MEETING MINUTES

Subject: 304 CONCRETION FACILITY DQO MEETING

Dept-Operation-Component	Area	Shift	Meeting Dates	Number Attending
WHC RCRA Closures	RCHN	Day	May 31, 1994 June 1, 1994	18

Figure 7-8. 304 Concretion Facility, East Wall Changeroom Wipe Sampling Locations.

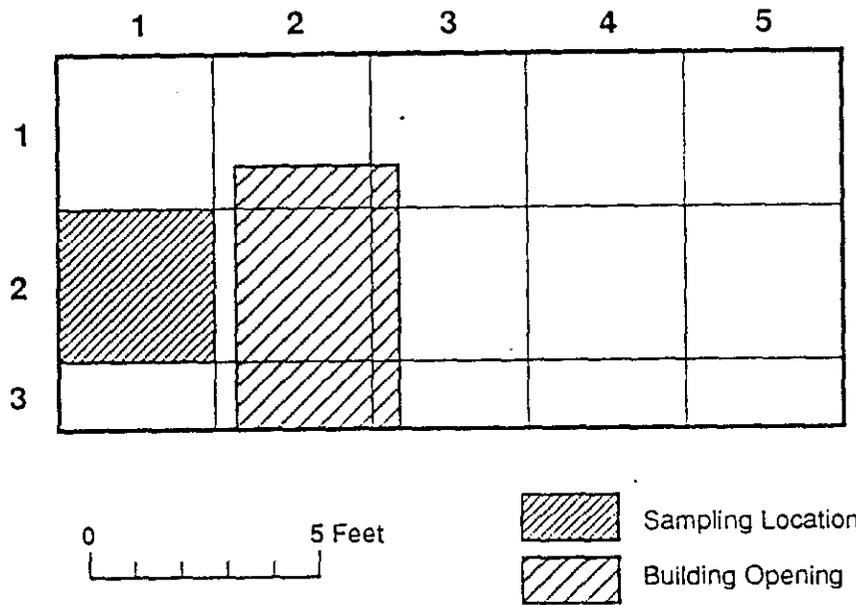
- Wipe sampling of the change room walls was eliminated from the initial sampling after decontamination. This reduction was made based on the agreement that the chances of contamination were low. However, if wipe sampling of the walls of the main building indicates that contamination is present after decontamination, then all four changeroom walls will be decontaminated and the east and west walls (Figures 7-8 and 7-10) of the change room will be sampled. *SM*
